YANAGAWA et al. Appl. No. 10/768,192 June 22, 2006

AMENDMENTS TO THE DRAWINGS

REMARKS/ARGUMENTS

Fig.4

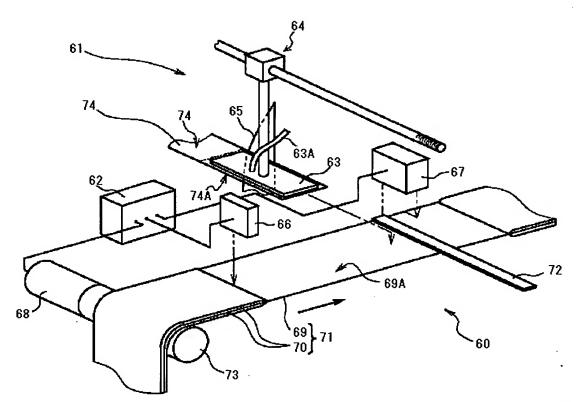
Addressing the issues raised in the outstanding Action in the order presented, it is proposed to amend Figures 4 and 5 to label them as "Prior Art" as the examiner requests. Replacement sheets are provided with this response.

With regard to no. 2, reference sign "63A" is not explicitly discussed in the description however in the context of the overall disclosure and the prior art referenced in these figures the nature and character of reference sign 63A will be apparent. Submitted with this response is a substitute specification attending to this and other adjustments requested by the examiner and made by applicants.

Attached are replacement, formal drawings. Figures 4 and 5 are indicated to be "prior art".

The relevant passages on pages 4 and 5 (referenced to the text as filed) have been amended in order to include a discussion of reference sign 63A. As this information pertains to acknowledged prior art, it is not critical to the disclosure of the present application. However, basis for these changes will be apparent considering the overall discussion presented relative to these drawings.
